**Staff Report to the  
Municipal Planning Board  
September 20, 2022**

**MPL2022-10066**

## LAKEHURST APARTMENTS

## PROPOSED BUILDINGS ELEVATIONS

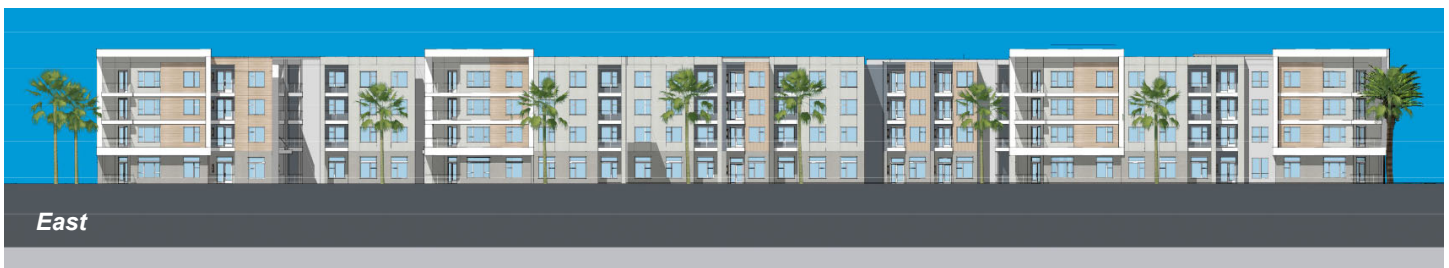
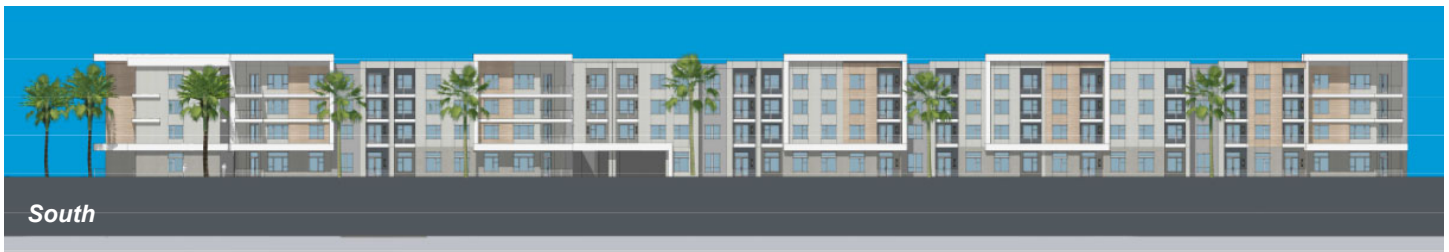
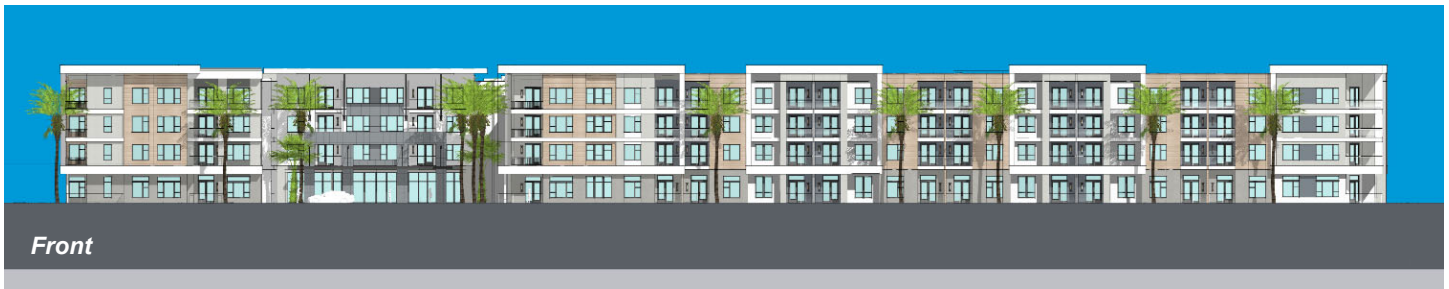
Staff is requesting that additional ornamentation and architectural treatments be added to the apartment buildings, as well as amenitizing the stormwater pond and treat it as a feature for the development. Additionally the applicant shows an 8 ft. front yard setback, where the setback requirement is 10 ft. Building will have to be moved 2 ft. to the east to meet the setbacks requirements for the zoning district, changes to be shown at time of Final Site Plan Determination.

- b. All facades shall be finished with the same materials and architectural details. Side and rear building facades that are visible from a public street shall contain architectural detail comparable in appearance and complexity to the front of the building. Durable materials such as stone, brick, or limestone must be utilized at the base of the building.

- c. The principal facade must include a public entryway that is clearly articulated and oriented to the adjacent public right-of-way. Entryways must include a substantial sheltering element such as a porch, awning, arcade, or portico.
